Subject: Submittal Supporting Accelerated ABWR Review Schedule

To: Glenn Kelly
From: PD Knecht
Subject: Responses to Questions

Reference: Clarification of Submittal on LOCAs Outside of Containment,
Memo: Kelly to Duncan, December 22, 1992

The following responses are provided to the referenced request for clarification on the information contained in SSAR section 19E.2.3.3, "Suppression Pool Bypass Paths".

Figure 19E.2-20A SMALL LOCAS OUTSIDE CONTAINMENT

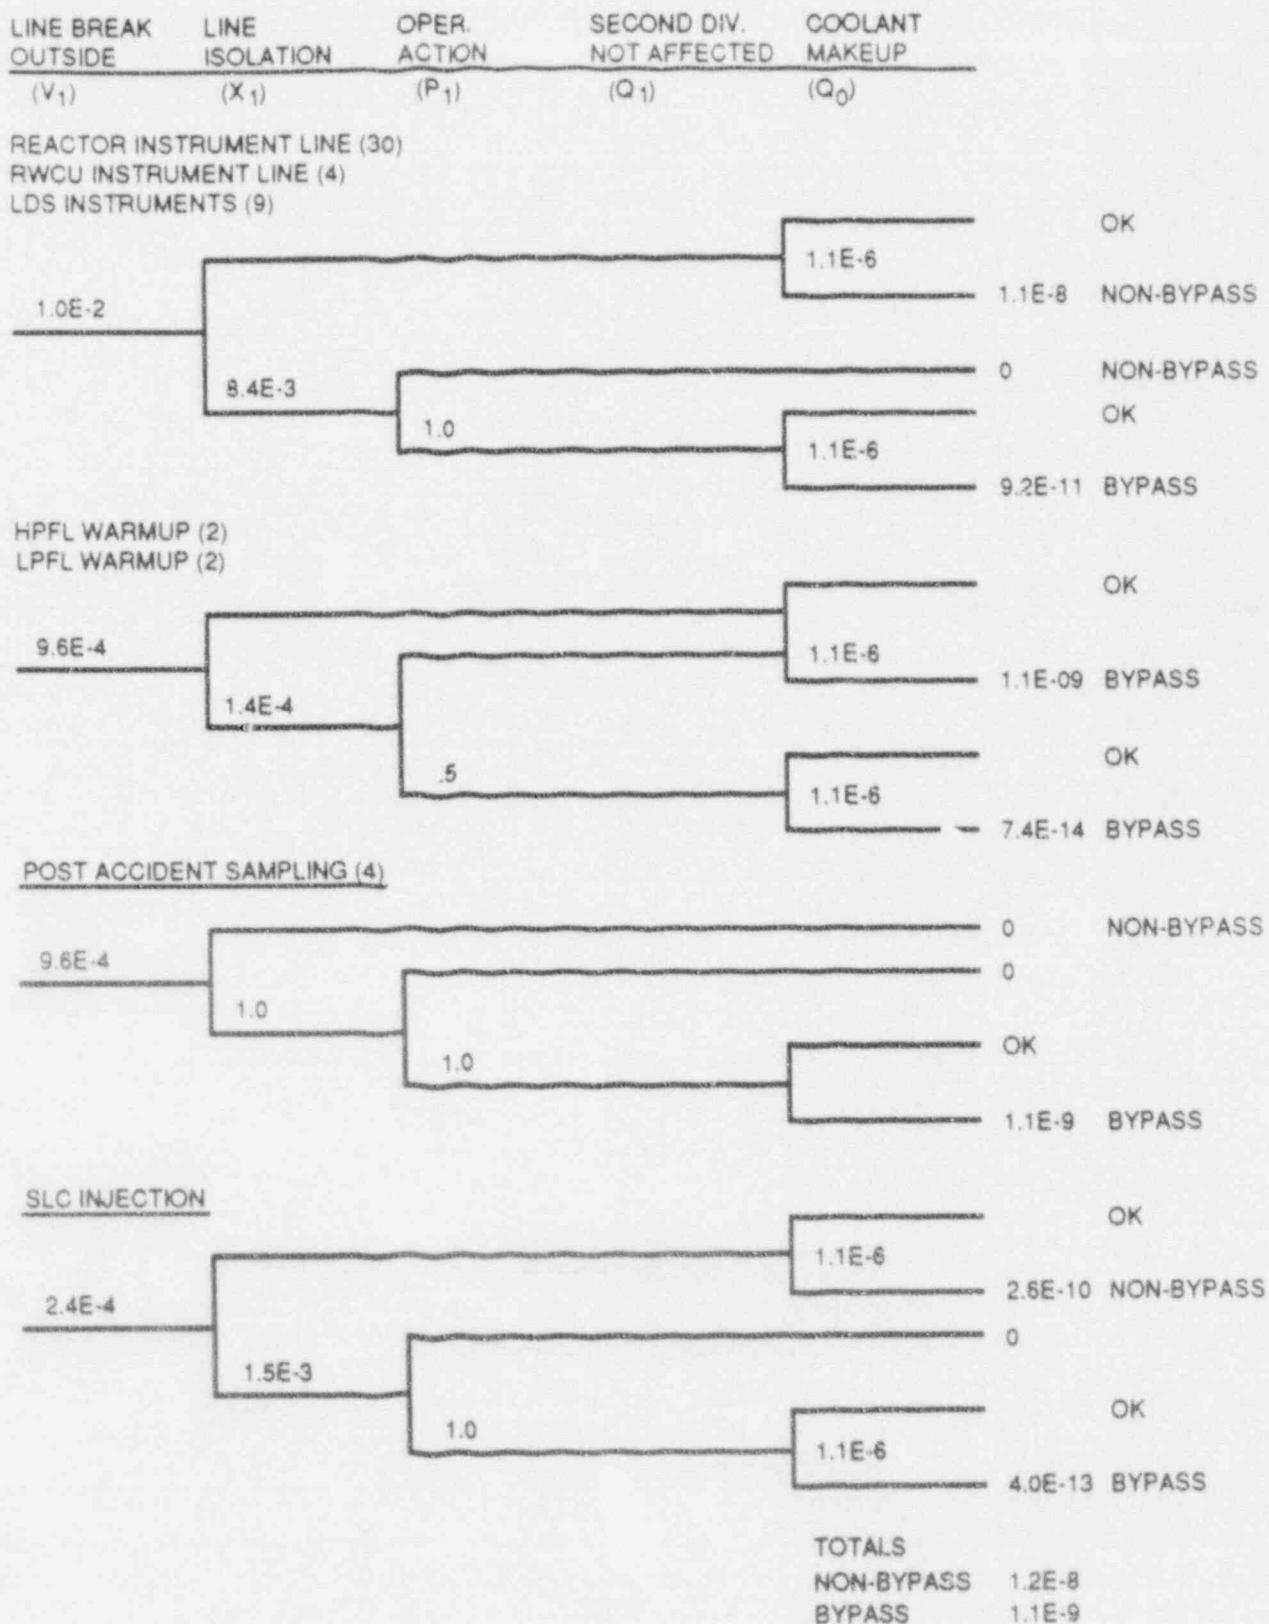
- (c) Equipment in an affected divisional area was not relied upon in the evaluation.
- 3. (a) For Figures 1, 2, and 3 in the December 17, 1992 GE draft SSAR submittal, explain how each value of X_i is calculated. It is unacceptable merely to state that the calculation is similar to other calculations in the staff's possession, although identical calculations can be referenced. (b) Similarly, provide the calculations for Q_o .

- (a) Figures 1, 2, and 3 of the December submittal are included as Figures 19E.2-20 a, b, and c in the revised section 19E.2.3.3. As indicated in section 19E.2.3.3.4, the calculation of X_i is based on the formulas shown in Table 19E.2-21. Because the line failure probabilities were treated separately in the Figure 19E.2-20 trees, the values corresponding to the number of lines and the break probabilities (P13, P14 and P15) were not included in the values indicated.

Figure 19E.2-20B MEDIUM LOCAS OUTSIDE CONTAINMENT

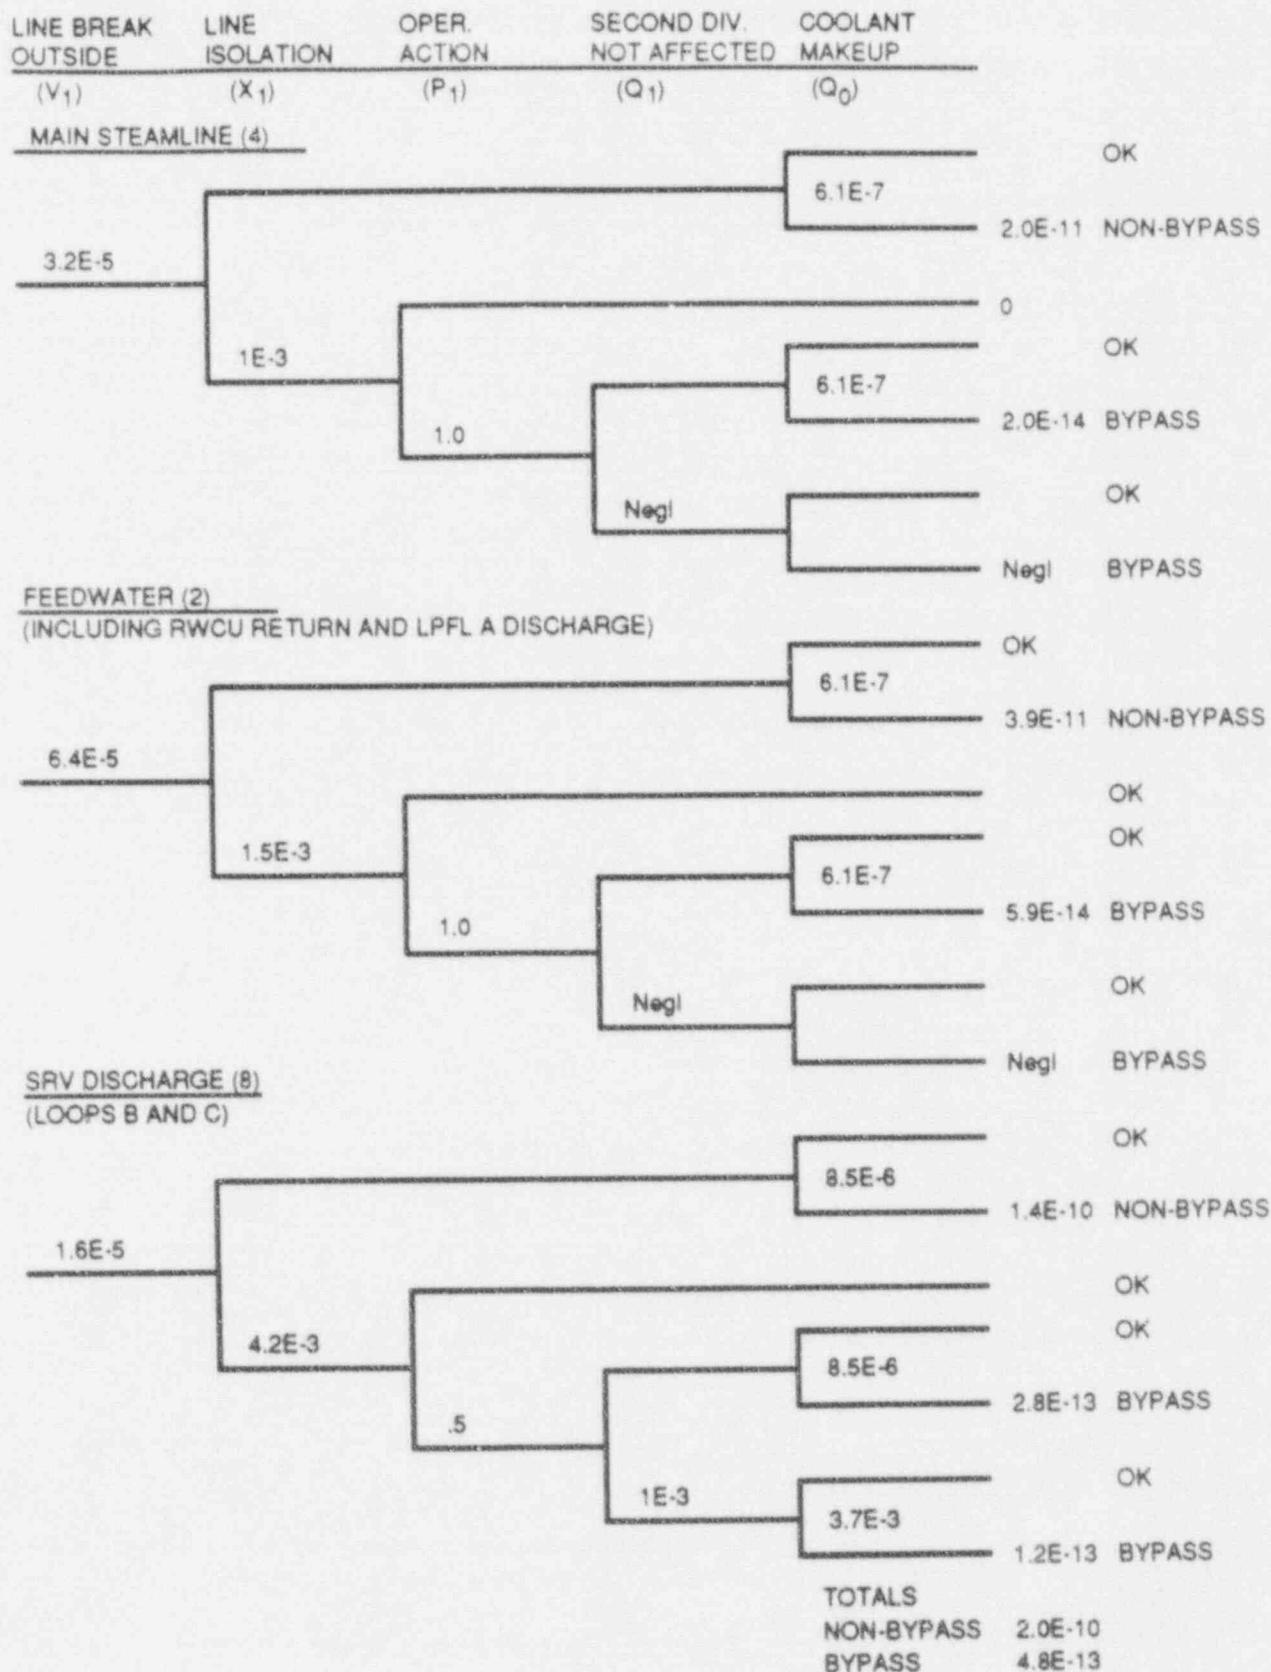
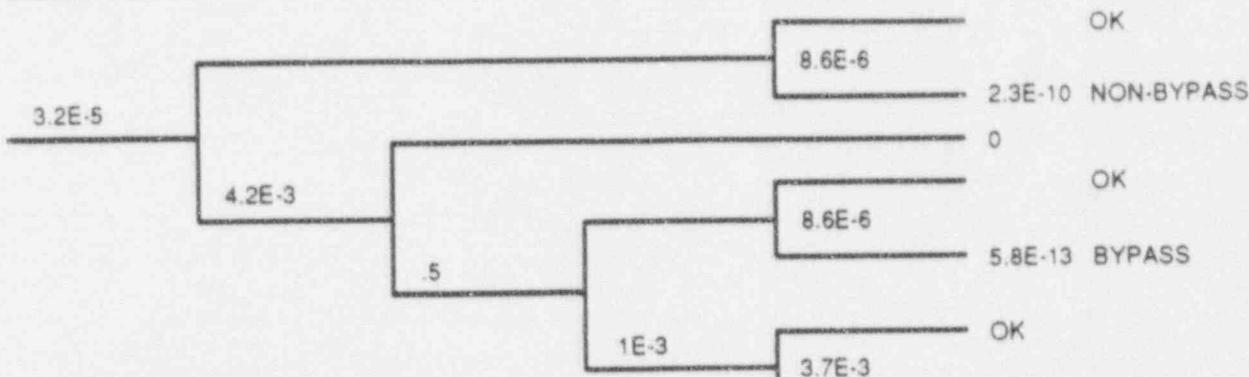
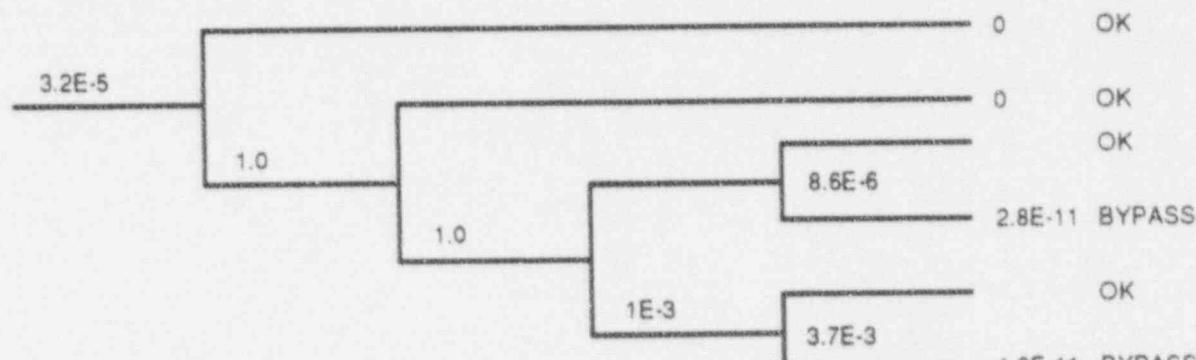
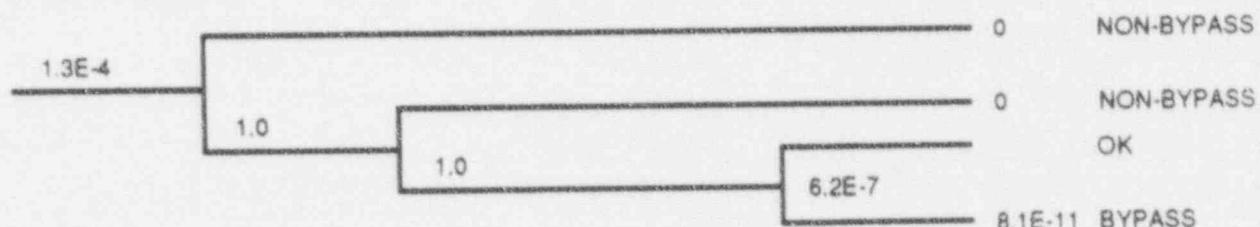
- 1. It appears that the value of Q_1 (failure of another division) was estimated to be 1E-3 if the LOCA in the secondary containment occurred near another division wall. (a) Please amplify on how this was determined and what was the basis for deciding which LOCAs were or were not 1E-3 events. (b) Also please explain how the values of Q_1 and Q_o in Figure 2 (Medium LOCA Outside of Containment) were determined.

- (a) The basis for the value of Q_1 is described in section 19E.2.3.3.4 as conservative engineering judgement. An impact on the second division was judged to occur primarily due to compartment pressurization or environmental effects. Since the reactor building equipment of concern is qualified for the steam environment and pressurization is largely accommodated by relief of the blowout panels, the probability of consequential effect was judged to be remote. A value of 1E-3 was considered to be consistent with this judgement.
- (b) The values of Q_1 in figure 2 (now Figure 19E.2-20B) was based on engineering judgement as discussed in the response above. The Value of Q_o is indicated in a table include with the discussion of Q_o in section 19E.2.3.3.4 for medium size LOCAs. The development of the tree shows the loss of divisions assumed.
